BUILDING ELEVATION

SECTION 1-1'

SECTION 22'

SECTION 33'

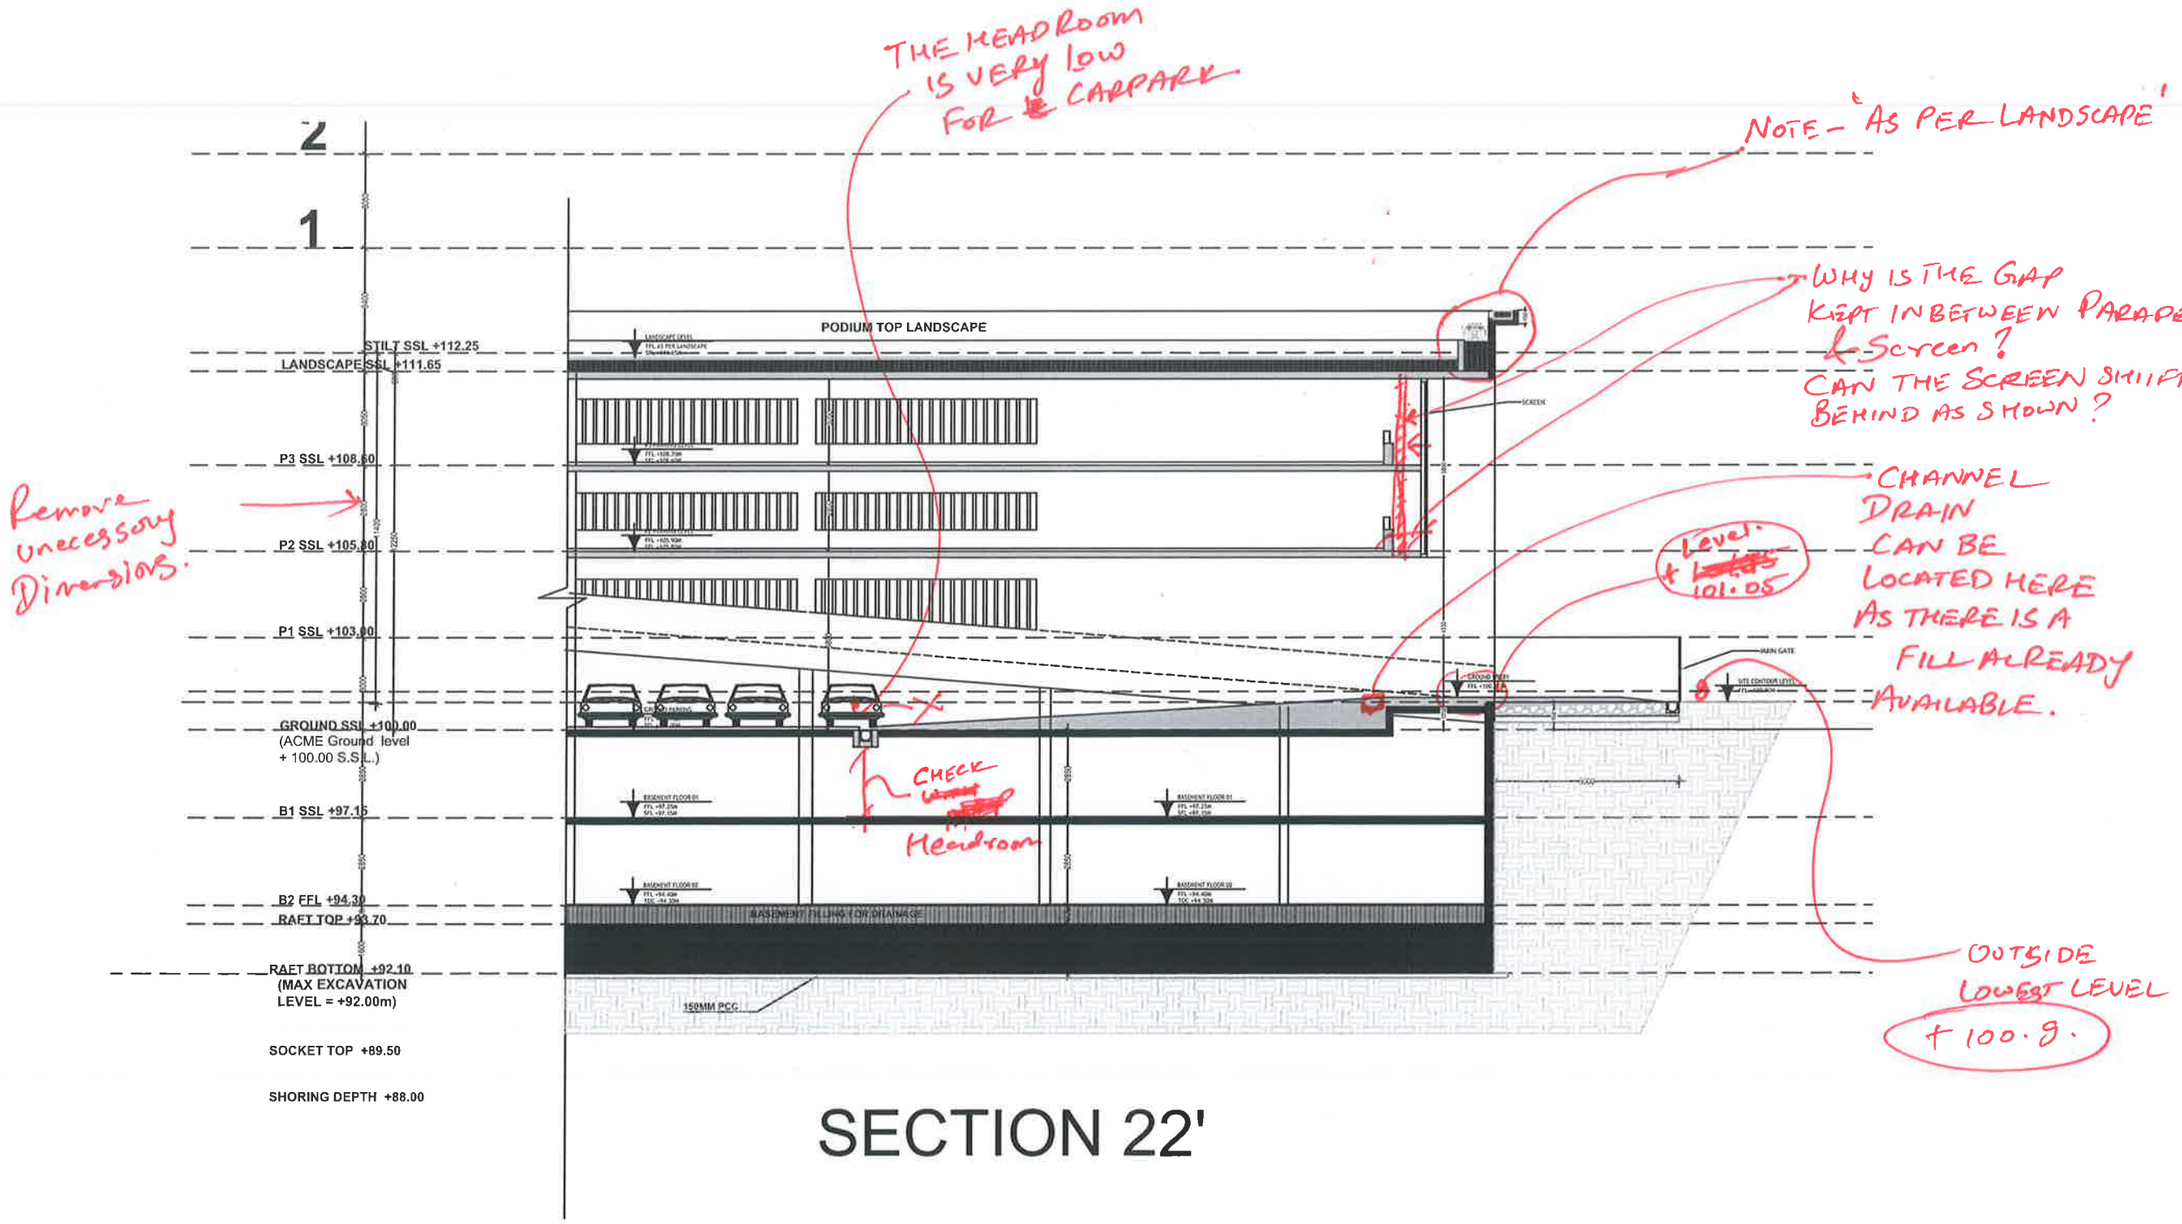
→ RAMP SLOPE TO BE CORRECTED.

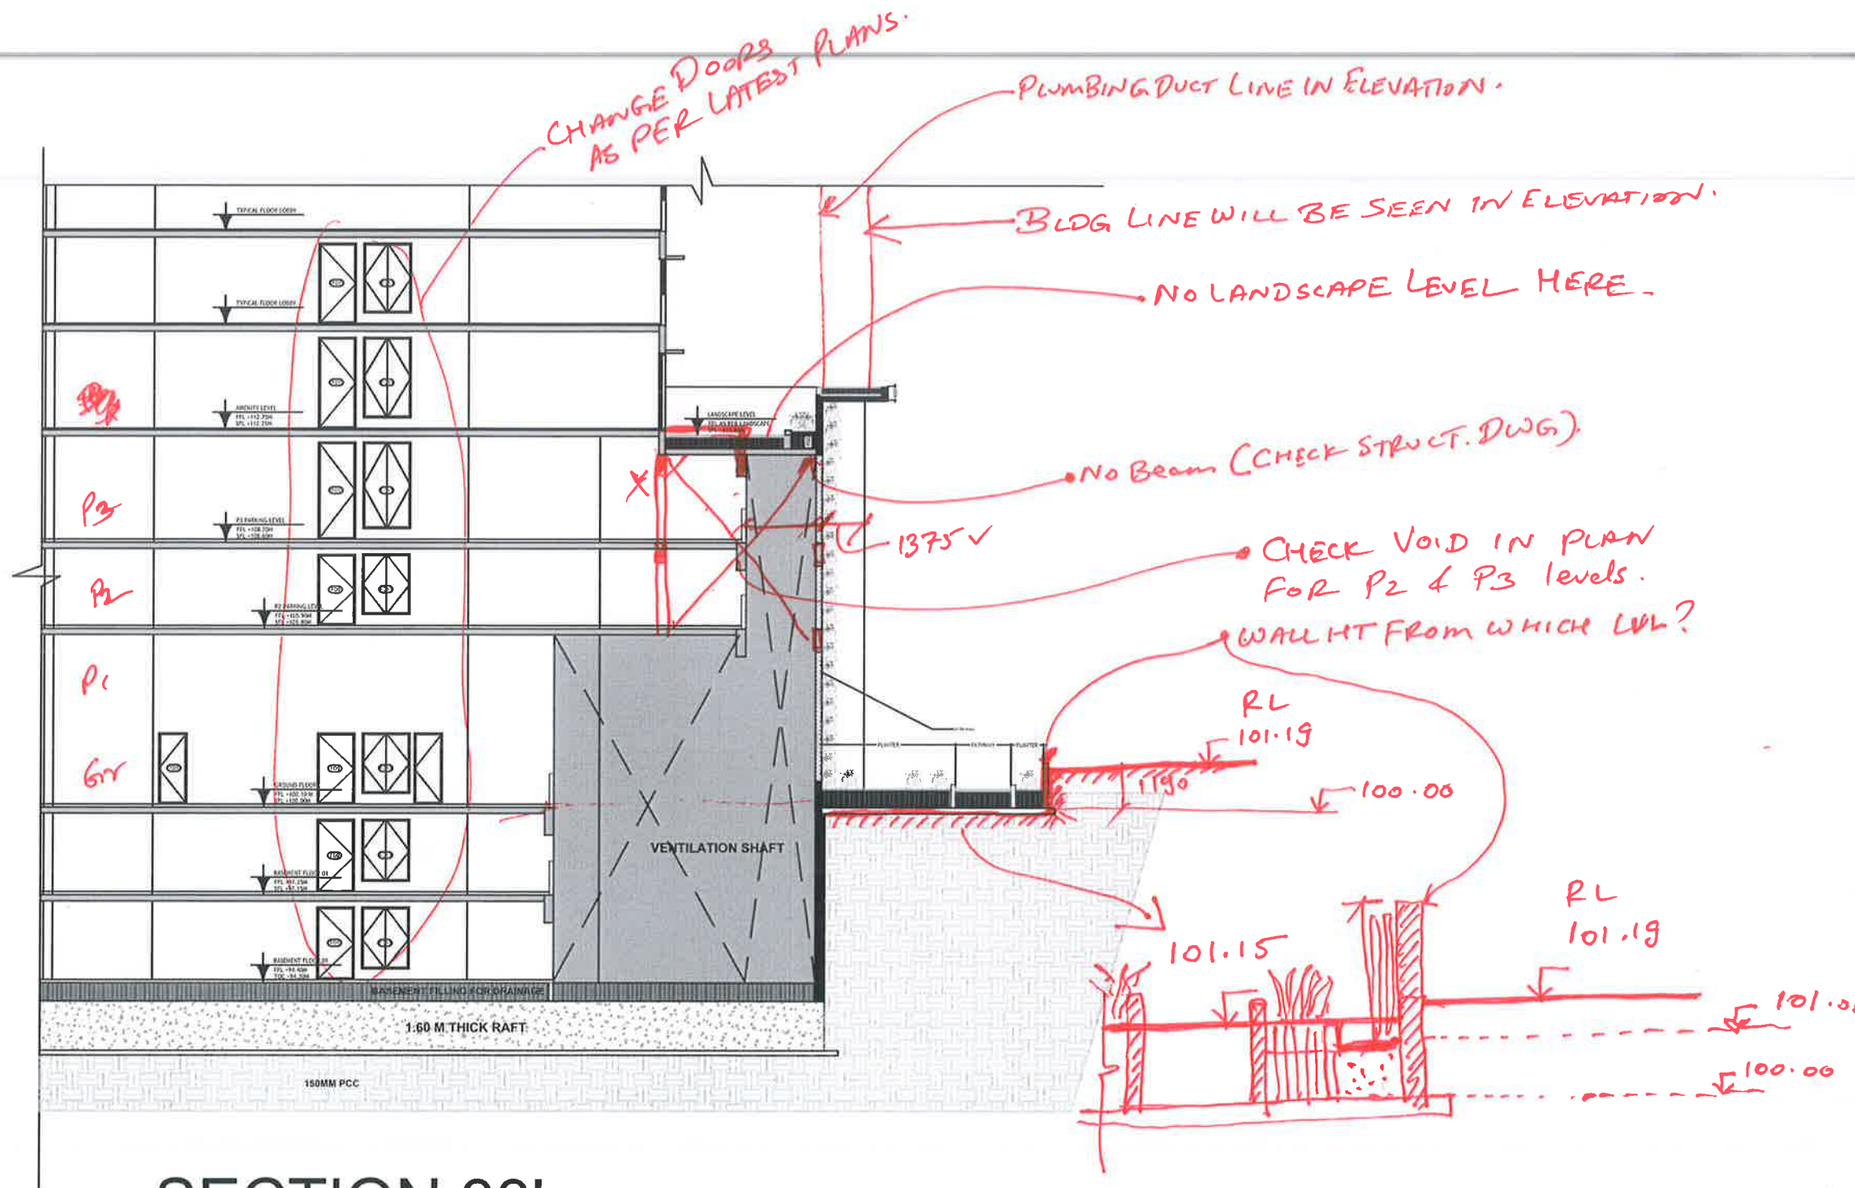
→ RAMP @ STILT LVL →

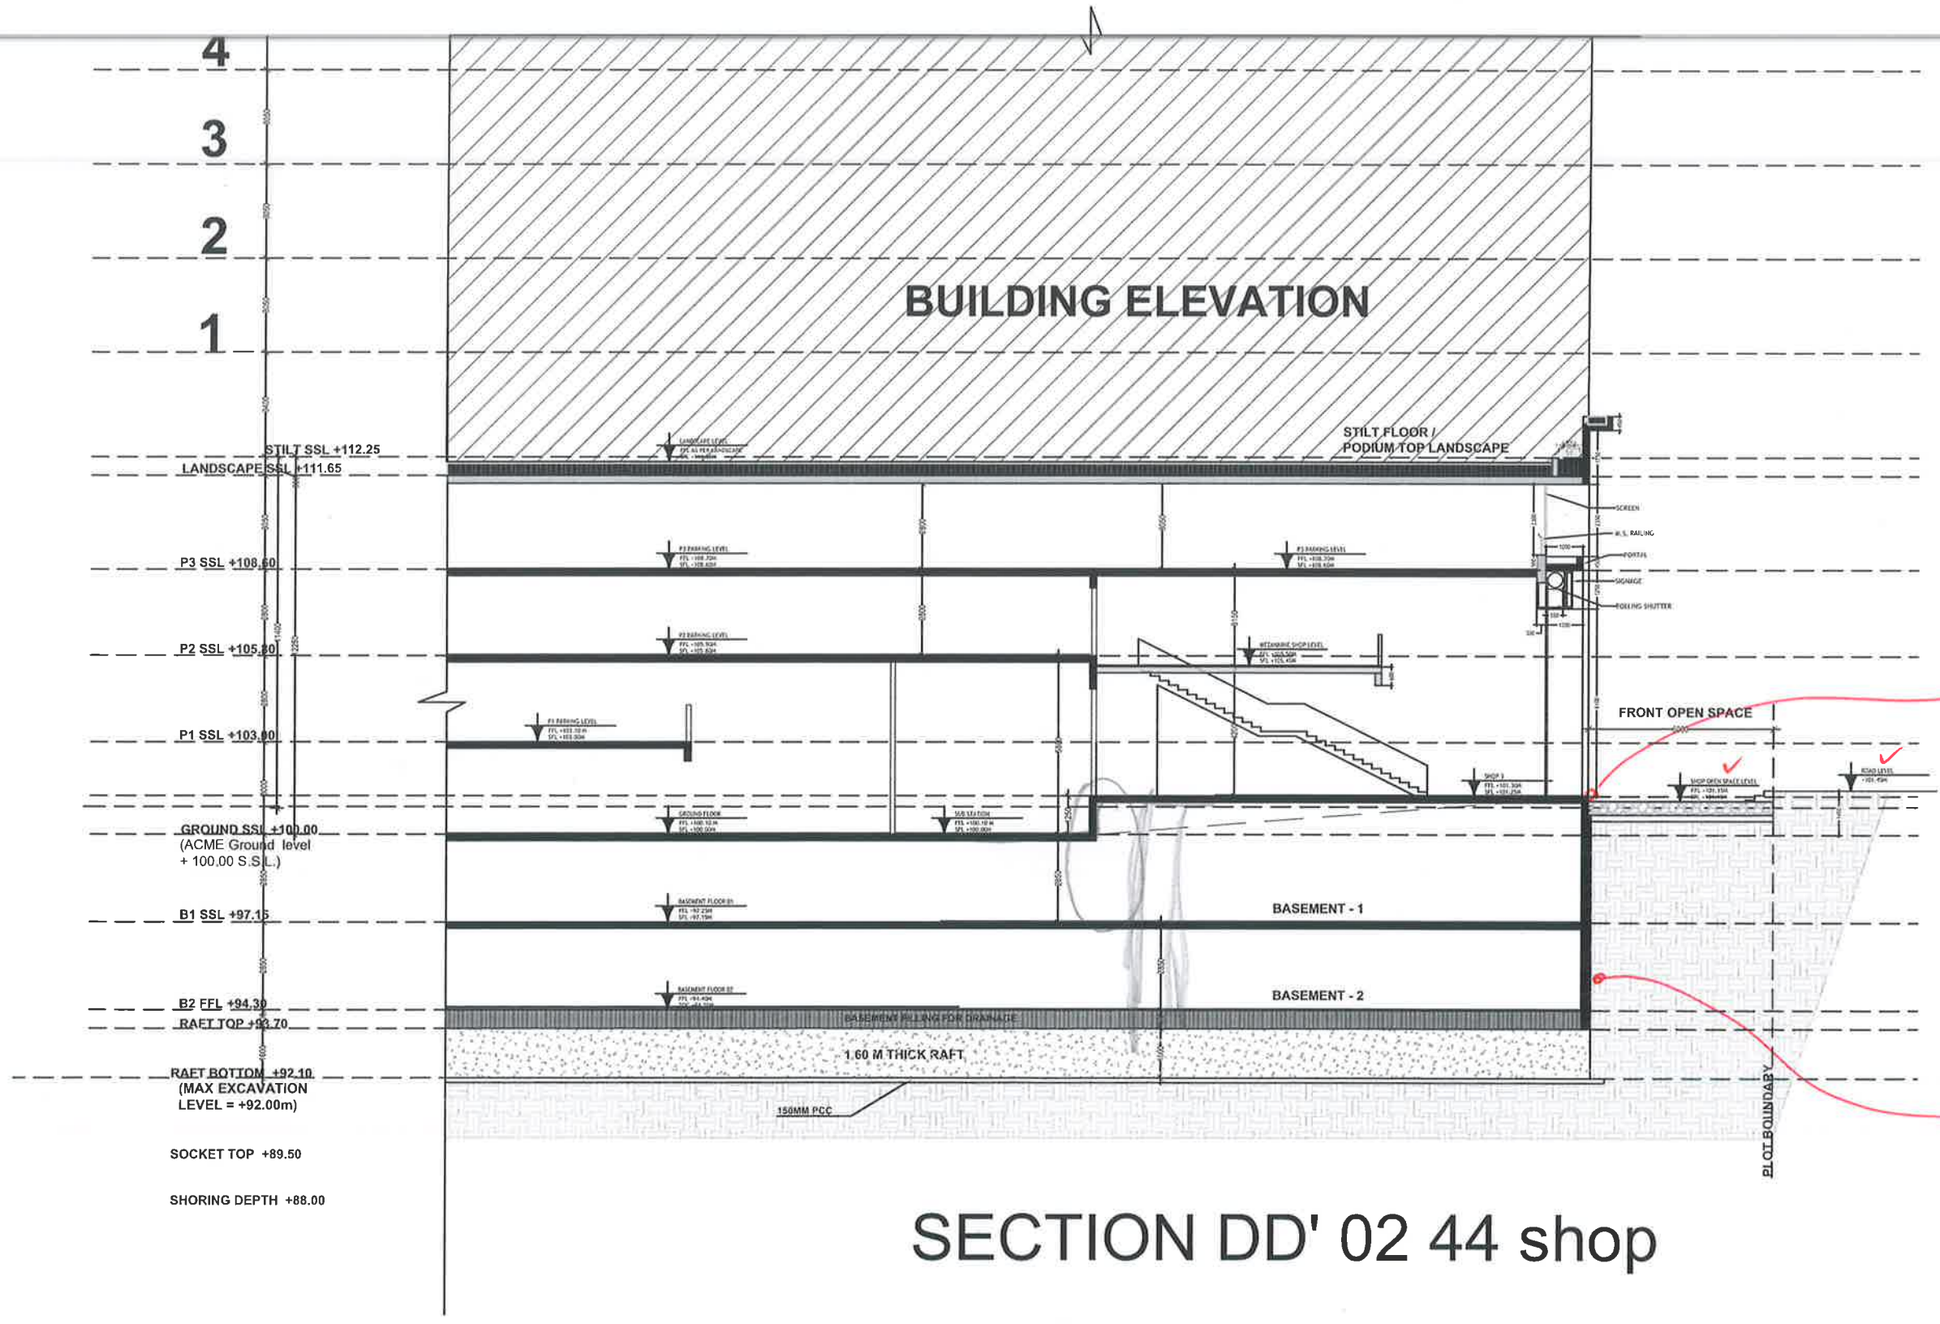
HT FOR DG HAS TO BE 4.5m Clear.

THE HEADROOM IS VERY LOW FOR CARPARK
NOTE - 'AS PER LANDSCAPE'
WHY IS THE GAP KEPT IN BETWEEN PARAPET & SCREEN? CAN THE SCREEN SHIFT BEHIND AS SHOWN?
CHANNEL DRAIN CAN BE LOCATED HERE AS THERE IS A FILL ALREADY AVAILABLE.
Level + 101.05
OUTSIDE LOWEST LEVEL + 100.9.
Remove unecessary Dimensions.
CHECK Headroom
2
1
PODIUM TOP LANDSCAPE
STILT SSL +112.25
LANDSCAPE SSL +111.65
P3 SSL +108.60
P2 SSL +105.20
P1 SSL +103.00
GROUND SSL +100.00
(ACME Ground level
+ 100.00 S.S.L.)
B1 SSL +97.15
B2 FFL +94.30
RAFT TOP +93.70
RAFT BOTTOM +92.10
(MAX EXCAVATION
LEVEL = +92.00m)
SOCKET TOP +89.50
SHORING DEPTH +88.00
BASEMENT FILLING FOR DRAINAGE
150MM PCC
SCREEN
MAIN GATE
